INSTRUCTION TO SERVICE

ITS: 61128		August 19, 2024
SECTION:	290-ELECTRICAL SCHEMATICS	
WRITTEN BY:	Ilan Kizner	
SUBJECT:	Rework - Rear ESS LV connector	
ISSUE:	Corrosion damage to connector	
SUMMARY:	Rework LV connector to prevent water intrusion and corrosion.

Figure 1 - Rear ESS LV connector.

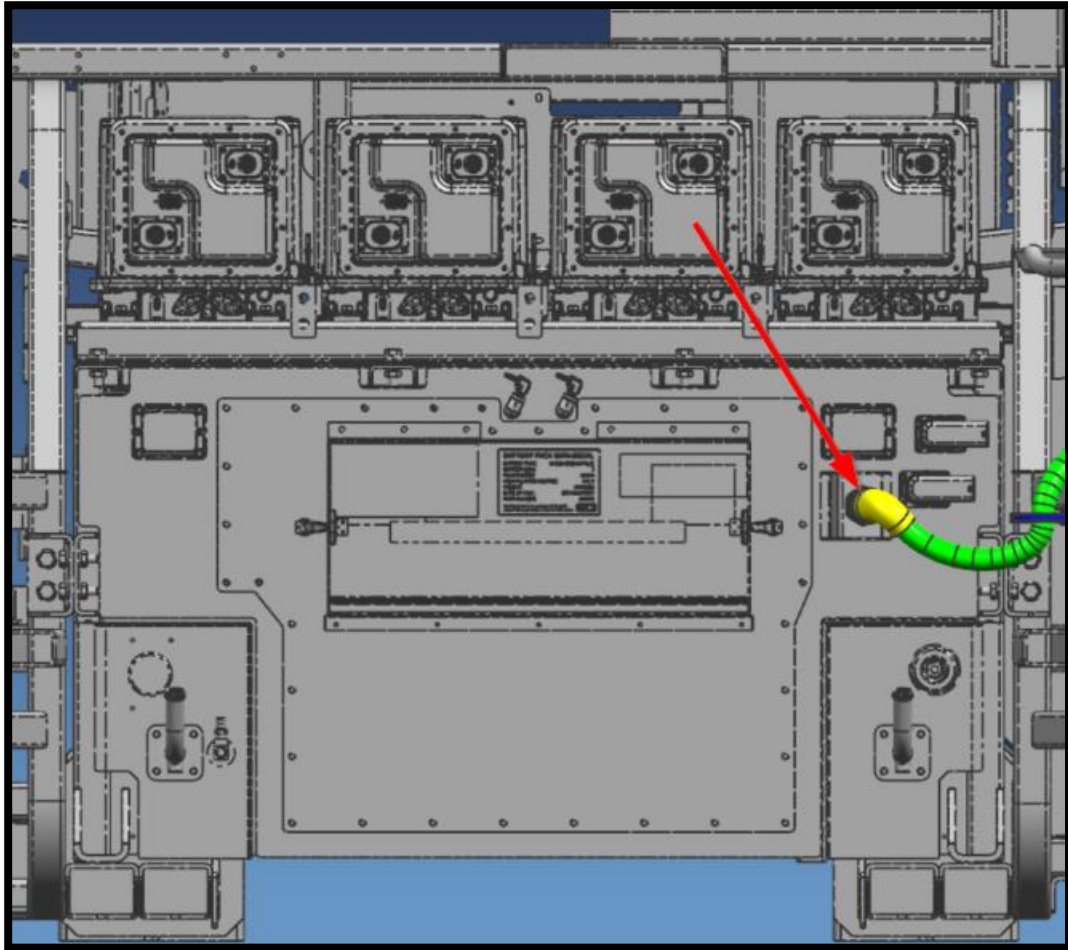
2.1 Access the rear ESS and locate the LV (Low Voltage) connector as shown in figure 1.

Note: D45e coaches will name this connector as EC-XBAT-45, and D45CRT/LE e will have that as EC-XBAT-34. Will be marked as EX-XBATxx throughout the remaining document.

2.2 Disconnect the LV connector from the ESS.

Figure 2 - location of added saddle base (CS, rear of the coach)

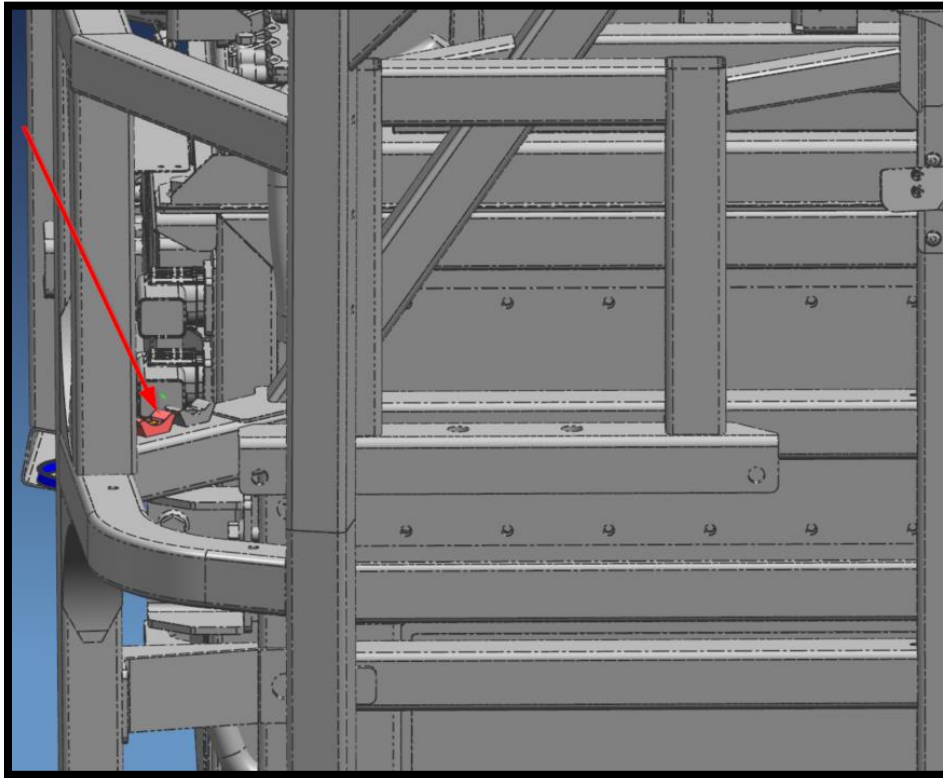
2.4 Install the provided saddle base 19-11-1008 on the location shown in figure 2. Attach the saddle by drilling a 1/4" inch hole at the location shown in figure 3.

Figure 3 - Drilling location of saddle base.

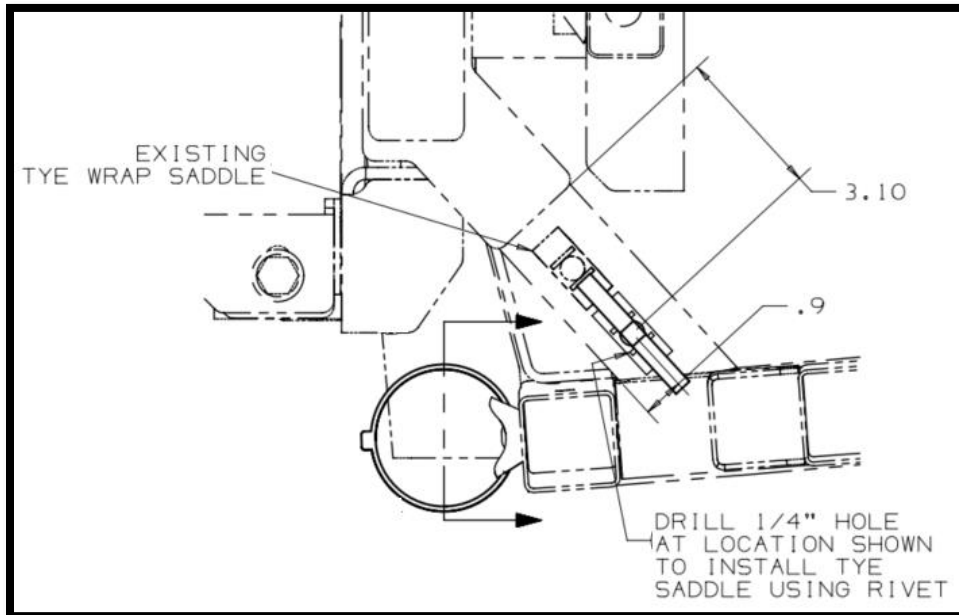
2.5 Secure saddle base 19-11-1008 using rivet 19-13-291.

Figure 4 - Second saddle base location (view from engine compartment)

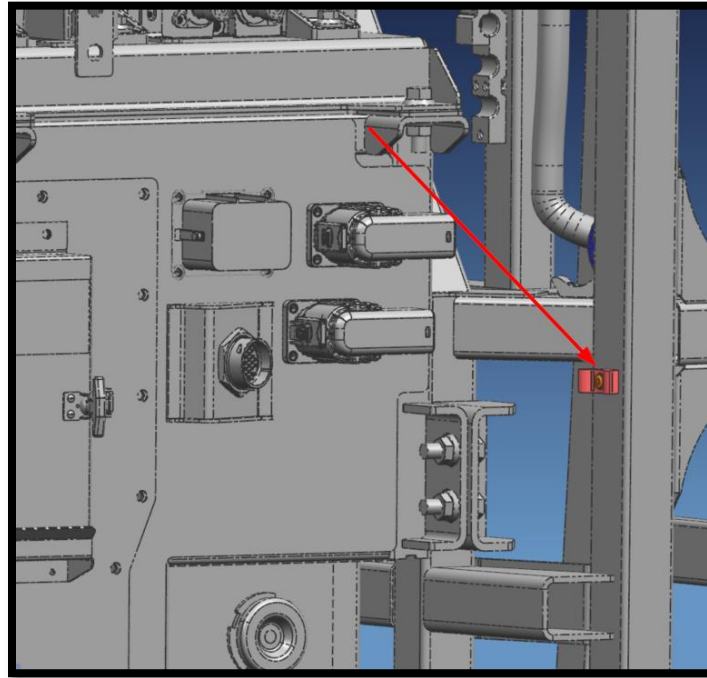
2.6 Install the second provided saddle base 19-11-1008 on the location shown in figure 4. Attach the saddle by drilling a 1/4" inch hole at the location shown in figure 5 and securing the saddle to the frame using rivet 19-13-291.

Figure 6 - Jumper Harness securement (View from Engine compartment)

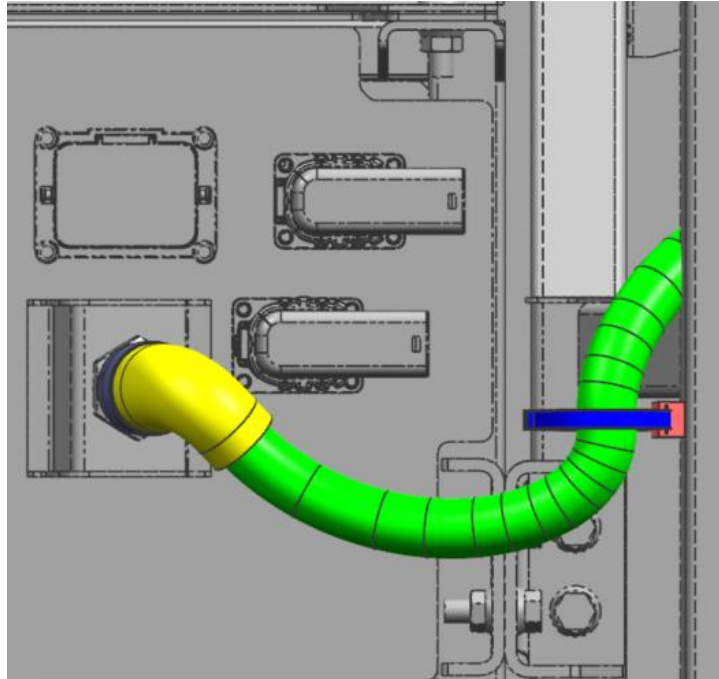
2.7 Connect provided jumper harness 1088103 to EC-XBATxx. route harness through saddle tyrap and secure connectors to prevent wire strain as shown in figure 6&7.
